ADDENDUM

Project: TJ Majors Building Upgrade

Project No.: 14-040

Addendum No.: 1

2. Sheet M1.1

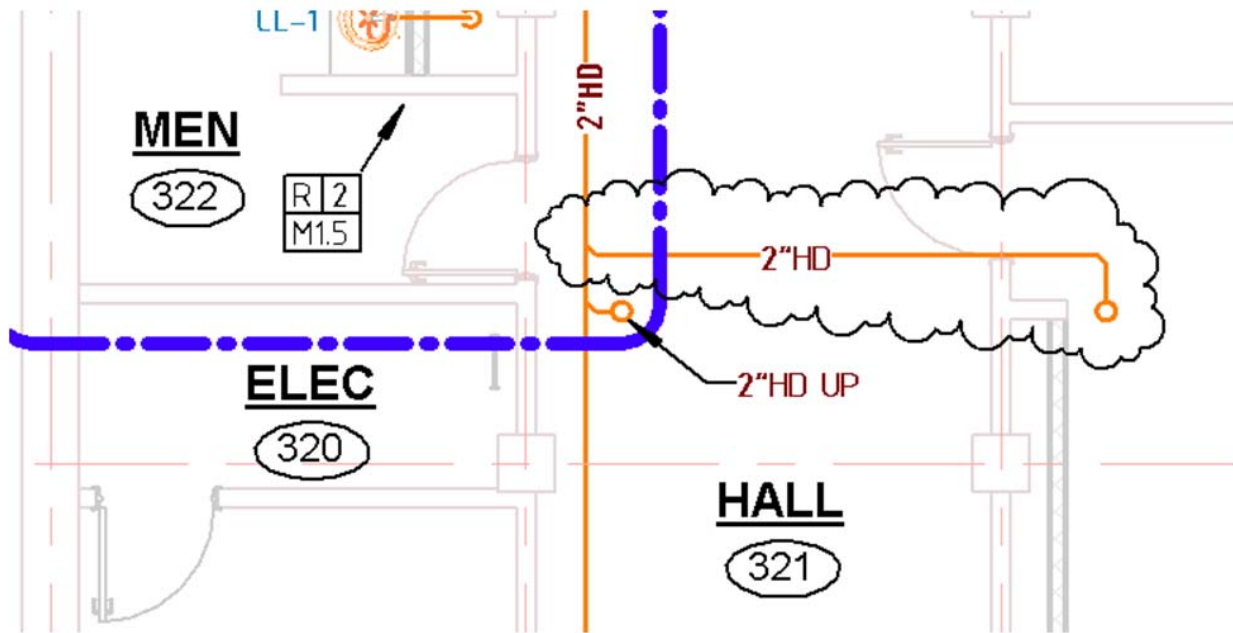
A. **Mechanical Floor plan –**

- 1) Add note 11 to read "install PT ports on supply and return piping at an accessible location. Install in horizontal section of HPS and HPR piping just before entering chase to attic, HPS and HPR piping before leaving mech 111 to stor 122 and in HPS and HPR piping in stor 122 before a branch take-off.
- 2) Install steam heat exchanger (HE-1) and associated piping as shown on attached drawings.

4. Sheet M1.4

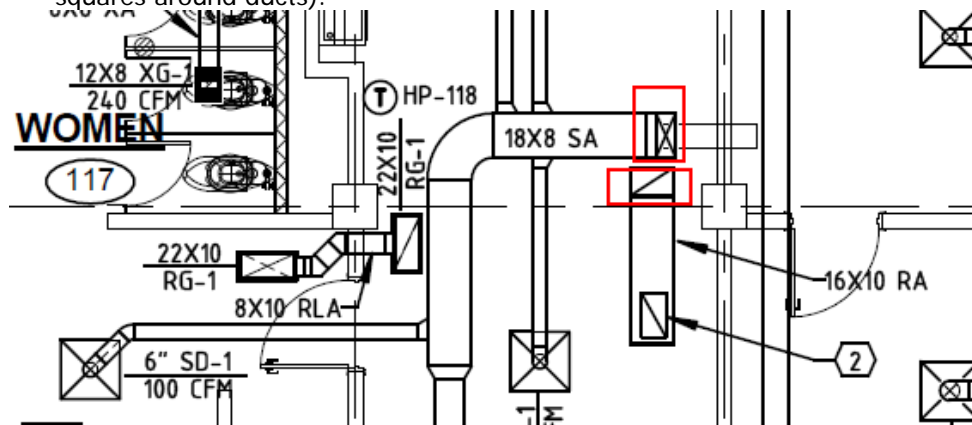
A. **Mechanical Floor plan –**

- 1) Revise heat pump return piping to be 3" starting after HP-206 going north.
- 2) Revise note 11 to read "Mechanical contractor to provide piping support for mechanical piping to be fastened to the existing structure (typical). Supports to be roller chair pipe support or a flat steel plate with side rails (to prevent perpendicular movement)."
- 3) Add note 13 to read "install PT ports on supply and return piping at an accessible location. Install in vertical section of HPS and HPR piping above chase to first level and in HPS and HPR piping in front of new southeast stair. "

6. Sheet M2.2

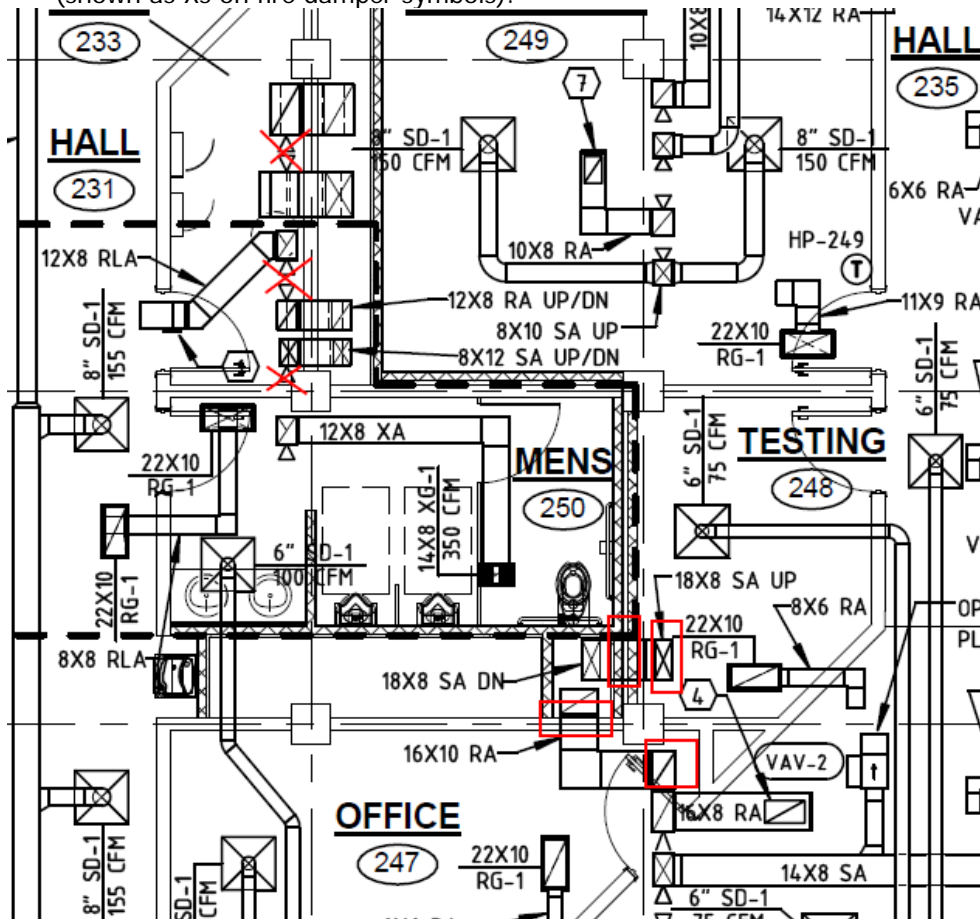
- 1) Add fire damper to 16x10 Return air and 18x8 supply ducts from HP-118 (shown as squares around duct)
- 2) Delete fire dampers in mech 233 as there will be a rated shaft that offsets around the duct (shown as Xs on fire damper symbols).

7. Sheet M2.3

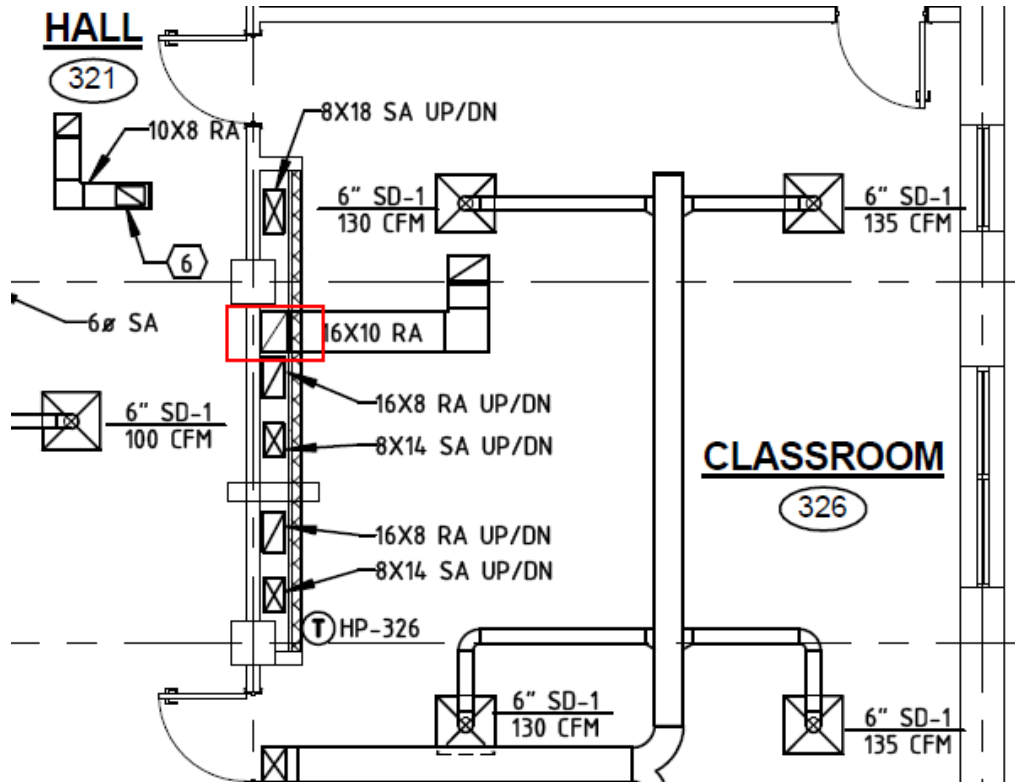
- 1) Add fire damper to 16x10 Return air duct from HP-118 (shown as squares around duct).

P 1 PARTIAL MECHANICAL - FIRST FLOOR

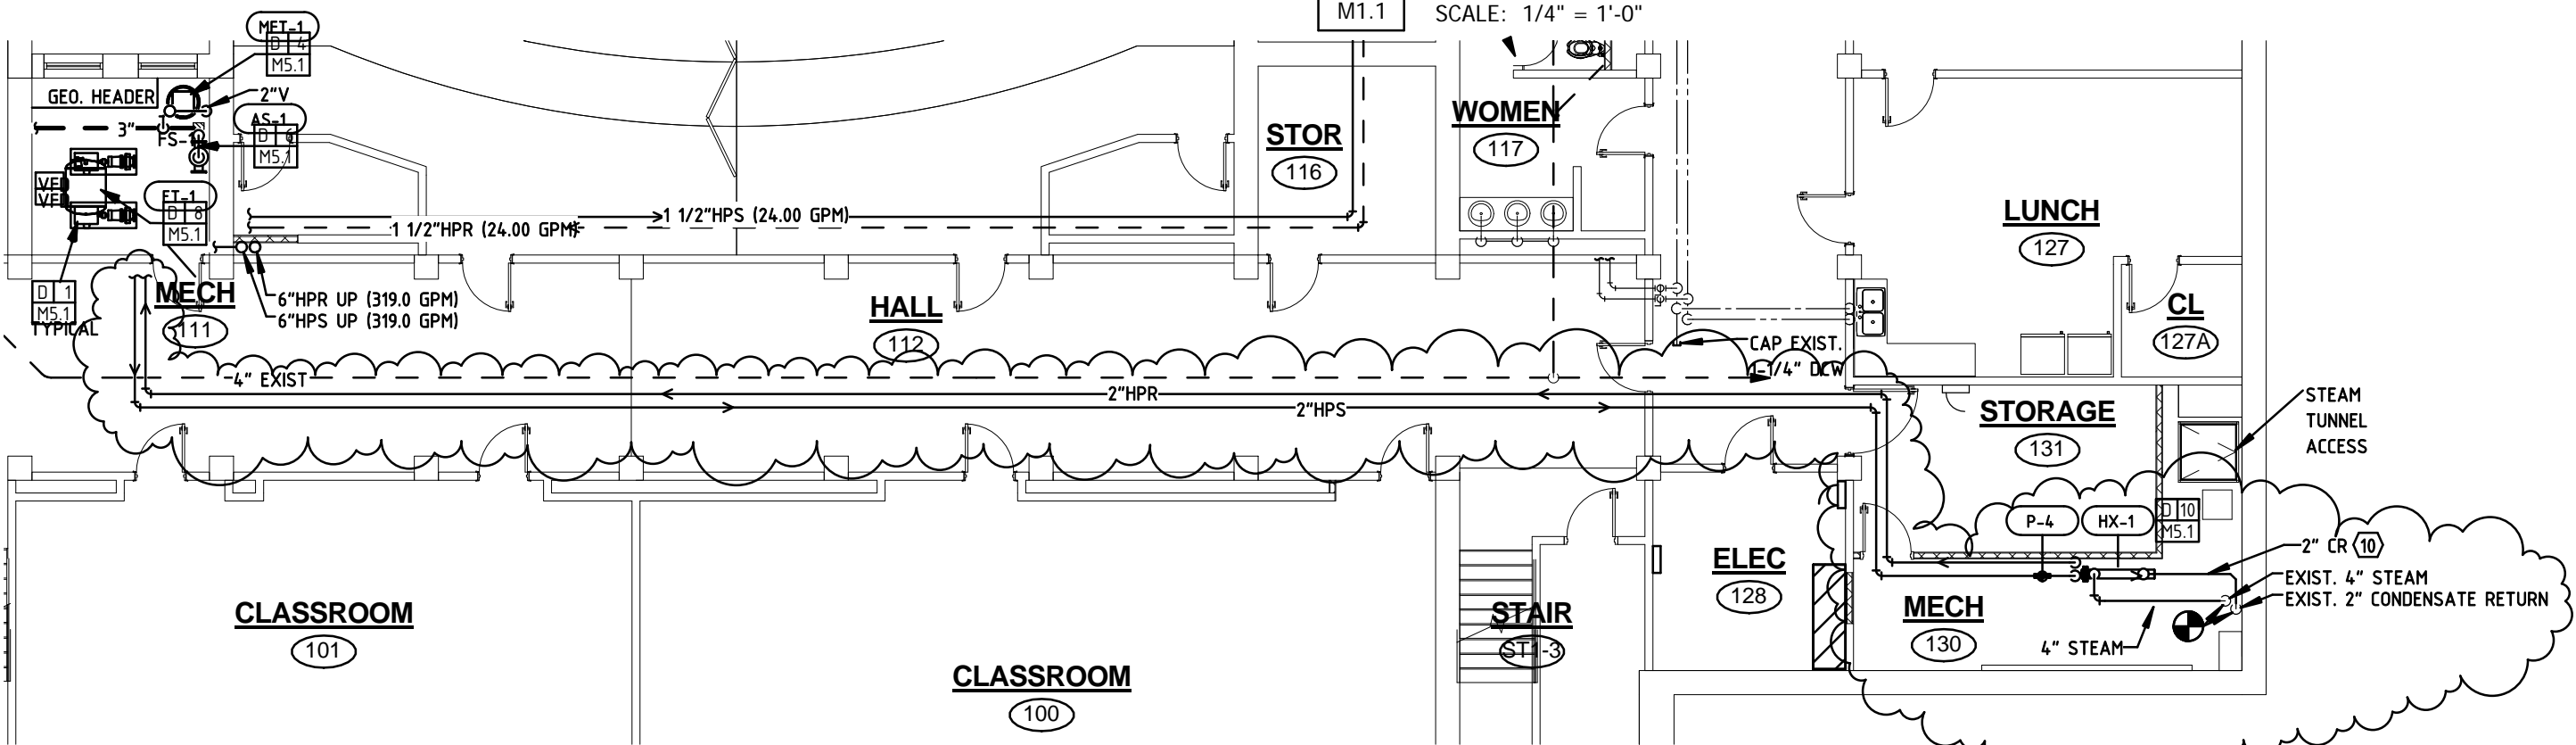
- 1) Add pump p-4 for heat exchanger. See attached drawing
- 2) Add shell and tube heat exchanger schedule. See attached drawing

- 1) Add electrical connection for new pump P-4 (see mechanical information in this addendum for location in this room). Provide STE disconnect, 2-#10 conductors plus #10 gnd in ¾" c. Route to Panel M3 and terminate to new 30/1 breaker.

D	10	HEAT EXCHANGER CONNECTION DETAIL
M5.1	NO SCALE

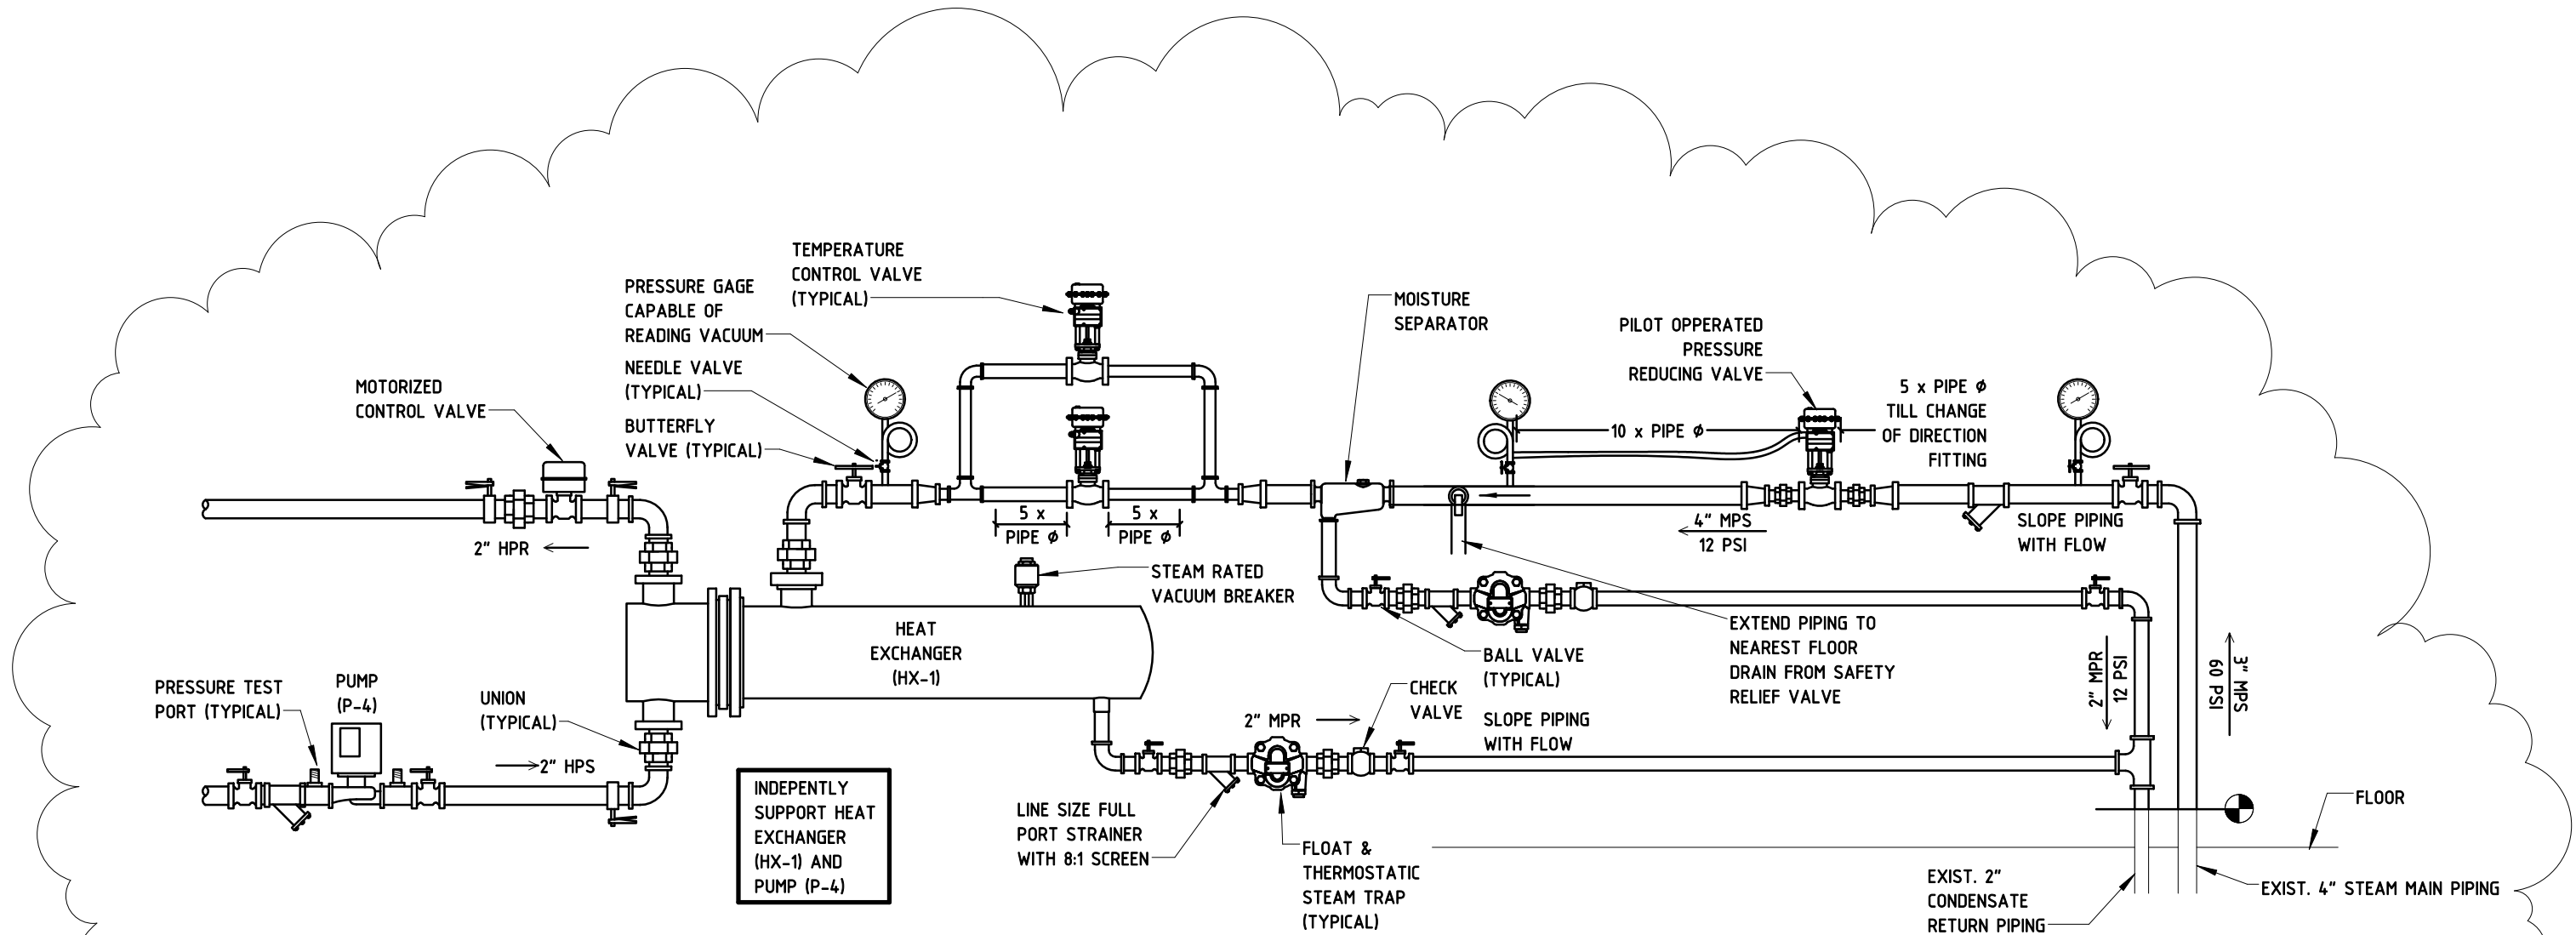
- 1) Detail shall be changed to Heat Exchanger Connection Detail and as shown on attached drawing.

D	3
M6.1

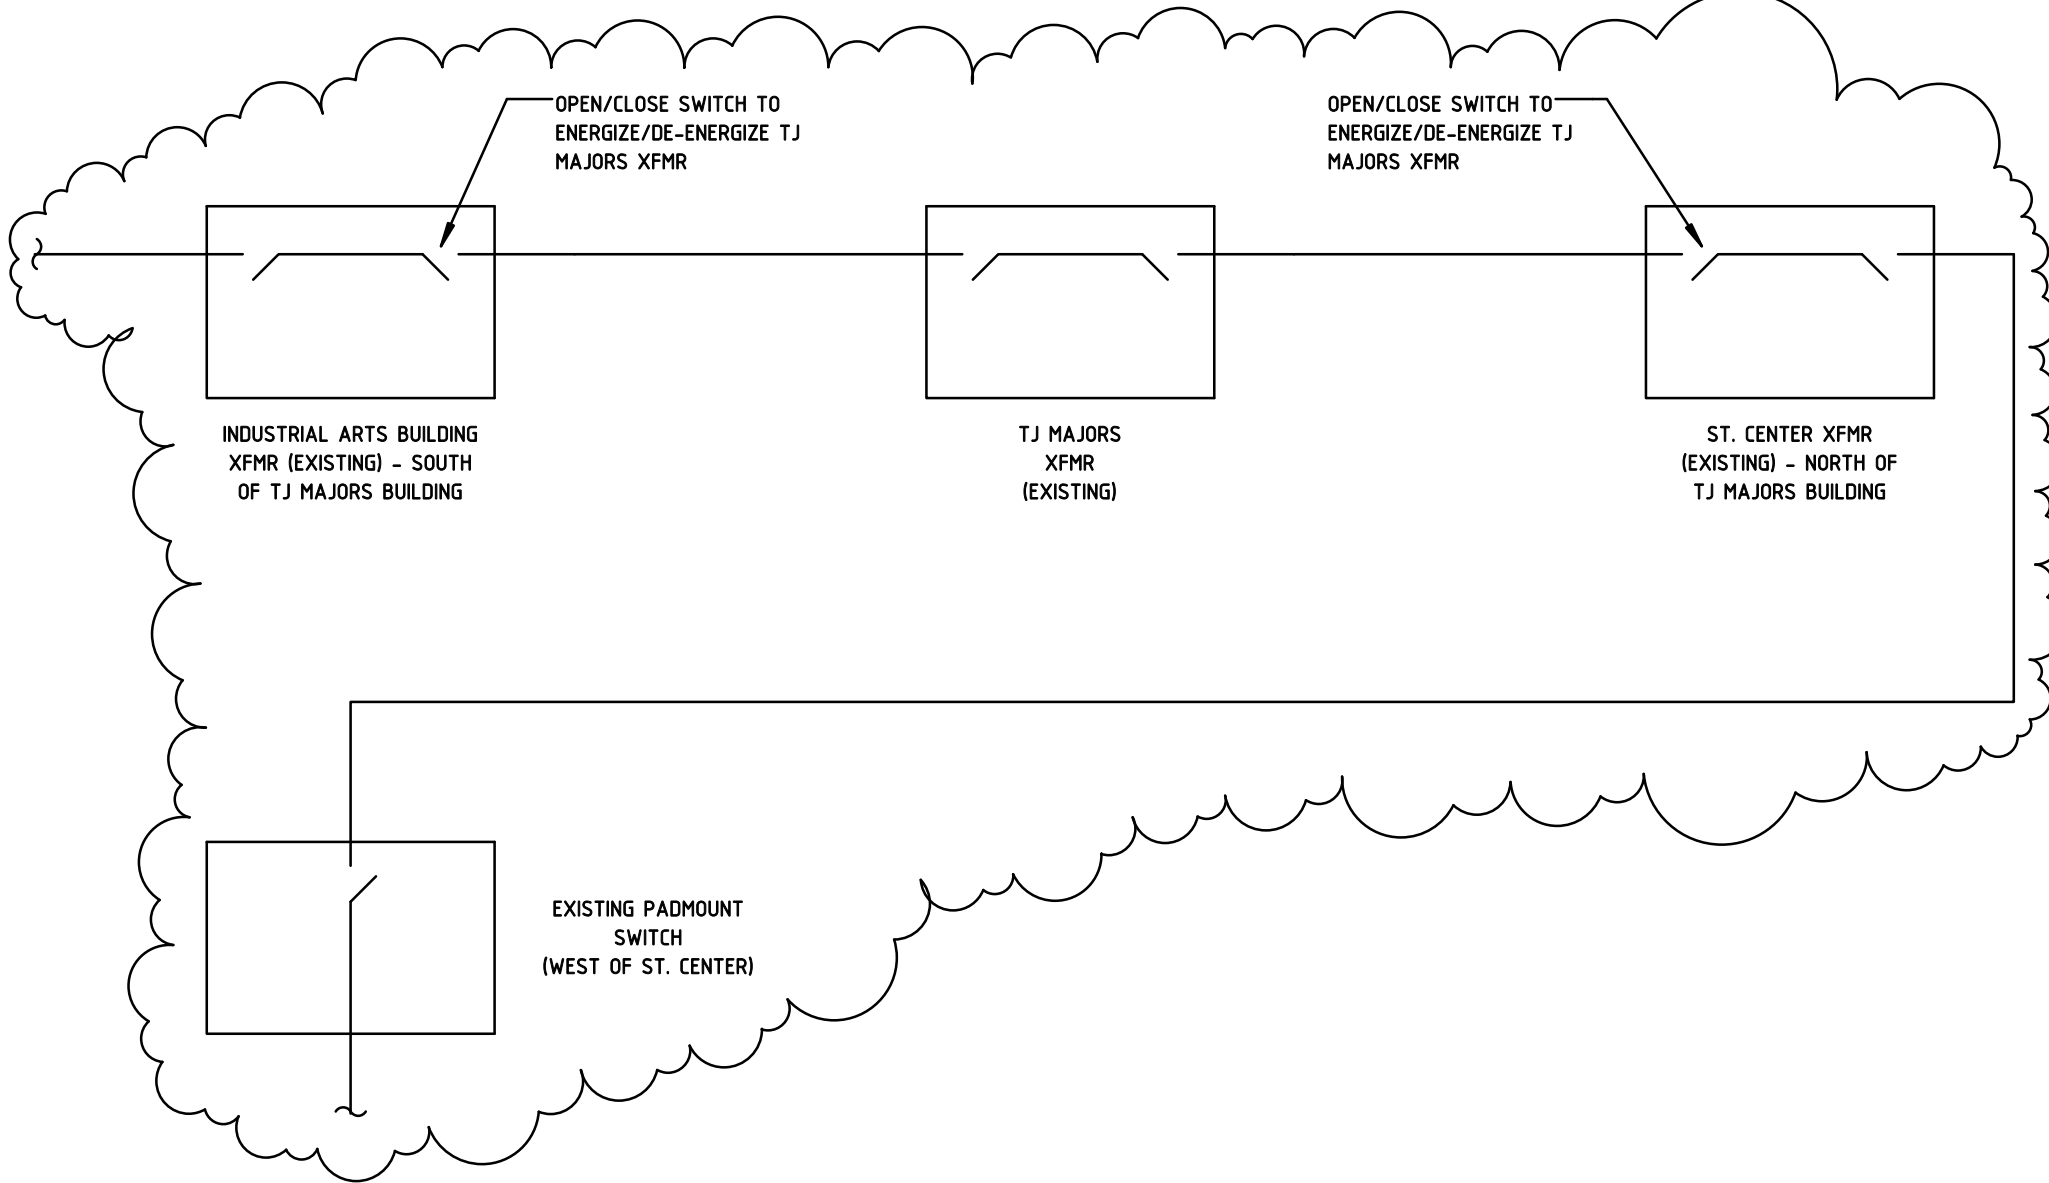
- 1) Add sequence of operation for steam heat exchanger with associated steam controls, pump, control valves and added temperature sensor. See attached drawing
